CONSULTATION PAPER FOR PROPOSED MODIFICATIONS TO THE TRANSMISSION CODE

4 SEP 2023

Table 1: Proposed Modifications to the Transmission Code

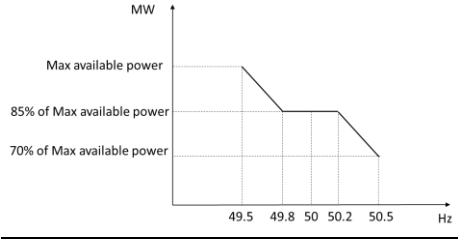
TC/2023/17	6.12.7	<i>Connected person</i> with solar photovoltaic system of installed capacity equal to or exceeding 1MWac at each site/facility, shall	<i>Connected person</i> with solar photovoltaic system of installed capacity equal to or exceeding 1MWac at each site/ facility location,	To clearly specify that the information to be provided to the Power System Operator

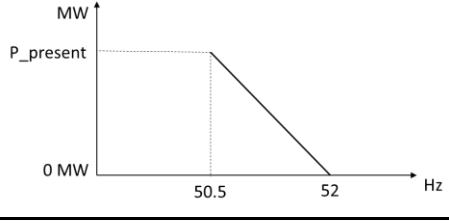
TC/2023/19	C1	<p>Each <i>Generation Licensee</i> or <i>Wholesaler Licensee</i> responsible for the <i>generation facility</i>, with the exception of solar photovoltaic systems, and seeking connection to the <i>transmission system</i> shall provide the information required in accordance with the format set forth in C.1.1 to C.1.3 of this Appendix for both primary and <i>alternate fuel</i> (for <i>generating units</i> that</p>	<p>Each <i>Generation Licensee</i> or <i>Wholesaler Licensee</i> responsible for the <i>generation facility</i>, with the exception of solar photovoltaic systems, and seeking connection to the <i>transmission system</i> shall provide the information required in accordance with the format set forth in C.1.1 to C.1.3 of this Appendix for both primary and <i>alternate fuel</i> (for <i>generating units</i> that are capable of operating</p>	<p>Currently, solar photovoltaic systems are being setup in various configurations by entities who may not be a Generation Licensee or Wholesaler Licensee. This requirement is updated to provide clarify on the parties that shall provide the</p>
